IEEE	P	802.	.20 <sup>TM</sup>	/PD·	<insert< th=""><th>PD</th><th>Num</th><th>ıber&gt;</th><th>·/V</th><th>&lt;<u>7</u>:</th><th>&gt;</th></insert<>	PD	Num	ıber>	·/V	< <u>7</u> :	>

# **Draft 802.20 Permanent Document**

<802.20 Requirements Document >

This document is a Draft Permanent Document of IEEE Working Group 802.20. Permanent Documents (PD) are used in facilitating the work of the WG and contain information that provides guidance for the development of 802.20 standards. This document is work in progress and is subject to change.

### 3.1.1 MBWA System Reference Architecture

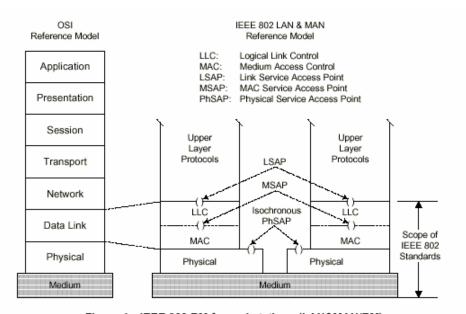
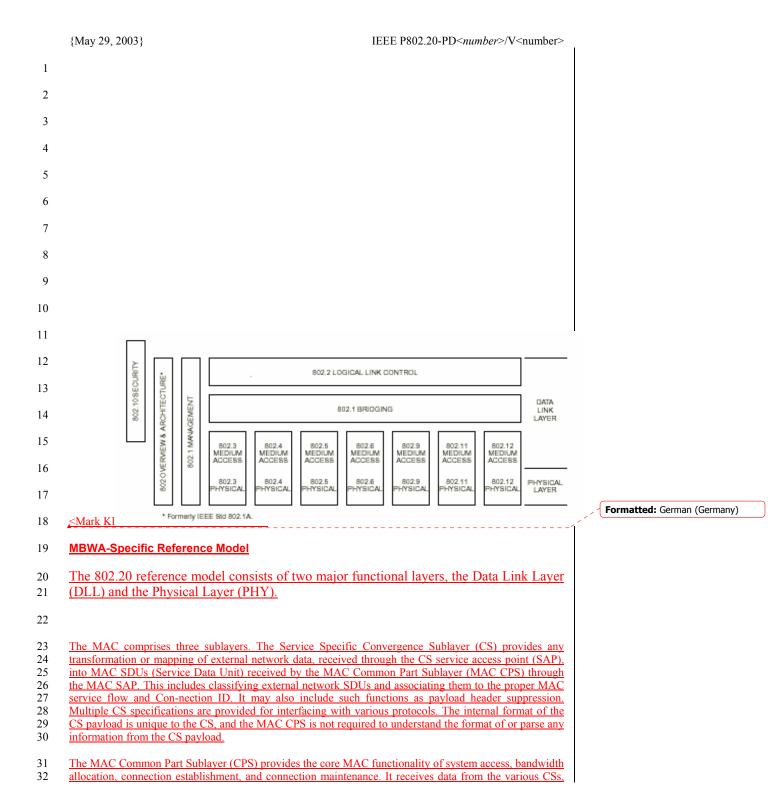
```
1
     through the MAC SAP, classified to particular MAC connections. QoS is applied to the transmission and
 2
     scheduling of data over the physical layer.
 3
     The MAC also contains a separate Security Sublayer providing authentication, secure key exchange, and
 4
     encryption.
     Data, physical layer control, and statistics are transferred between the MAC CPS and the physical layer
 5
 6
7
     (PHY) via the PHY SAP.
     I propose to adopt the MBWA-Specific Reference Model and its
 8
     explanation from the attachment, that will replace 5.1.1.
 9
10
     Reasons for that are:
11

- 802.1 bridging, in Fig. 2, is actually beyond the standard; including it in the standard scope will make the radio behave
12
13
     Ethernet bridge and will have implications in frame headers (look at
14
15

802.11 MAC, carrying if I remember well, up to four Ethernet addresses
16
     in the frame header);
17
18
       802.1 Management, in Fig. 2 is actually insufficient for access
19
     systems, being suitable only for LAN and WLAN systems;
20
21

- Security functions are not shown;
22
23
     - Management functions and their interaction with
24
         MAC/PHY/Security is not shown;
25
26
     - PHY interaction with the radio deployment is not shown.
27
28
     <Marianna 7/29/03>
29
                                                                                                    Formatted: Bullets and Numbering
30

# **MBWA** Interfaces

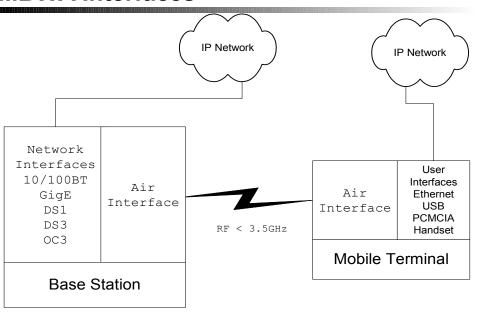
2 <Alan Chickinsky 8/7/2003>

Figure 1—IEEE 802 RM for end stations (LAN&MAN/RM)

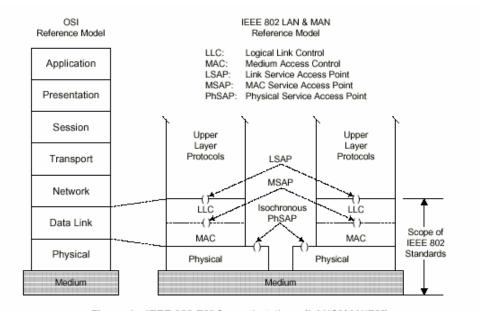
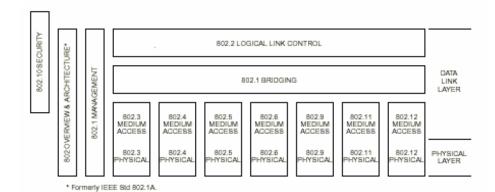
Action: Change the notations in the bubbles to point to the relevant section of the text (or remove the bubbles). <John Fan 7/23/03>
